# Interpretation

#### **Rule 096C Ground resistance requirements – Multi-grounded systems (2007 Edition, page 27) (6 October 2009) IR559**

Figure 1: Typical Wind farm network- single line diagram (only a few turbines are shown)

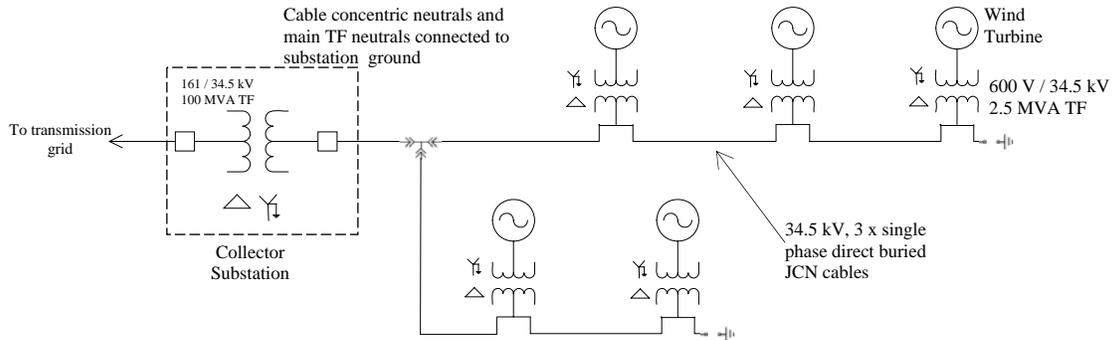
**Question:** The opinion of engineers in the industry is divided on whether the “four-grounds each mile” stated under Rule 96C is applicable to medium voltage underground cable systems for utility scale wind farms. These wind farm medium voltage cable systems typically consist of three underground single phase cables with Jacketed Concentric Neutrals (JCN). Each wind turbine would connect to the medium voltage system via LV/34.5 kV step-up transformer. The 34.5 kV underground cable system would be terminated at a 34.5 kV/HV substation before the wind farm is interconnected to the grid. A typical one-line diagram of a wind farm is shown below.

The 34.5 underground cable system could have a Delta connection at the turbine step-up transformers (LV/34.5 kV – Wye/Delta) and a Wye connection at the main power transformer at the substation. The cable concentric neutrals would be effectively grounded and bonded to the main power transformer neutral at the substation. The concentric neutrals will also be bonded to the low voltage secondary neutral of the turbine step-up transformers.

**For the underground cable system described above, is the “four-grounds each mile” requirement stated in Rule 96C applicable?** Additional information on different opinions in the industry is provided below. The additional details furnished are for information only and intended to further clarify the main question for which a code interpretation is sought.

The NESC applies to utility-scale wind farms, including the wind turbine generators, collector system cables and associated transformers shown in this Interpretation Request (“IR”). Whether four grounds are specifically required in each mile of the collector system cable neutrals depend upon the type of grounding selected and used at the individual step-up transformers: separate or interconnected grounding conductors and electrodes.

If the grounding conductors/electrodes for the step-up transformer cases, surge arrestors and associated equipment are separated from the step-up transformer secondary neutral grounding conductor/electrode, NESC rules do not require the collector cable neutrals to be grounded four times in each mile (but see specific requirements for random lay cable). However, the NESC rules do require the cable neutrals to be effectively grounded.

If the grounding conductors for the above items are interconnected using a single grounding conductor/electrode, the collector cable neutrals must be grounded at least four times in each mile of the entire collector system. NESC rules allow such interconnection providing applicable rules are met; the rules do not require interconnection.
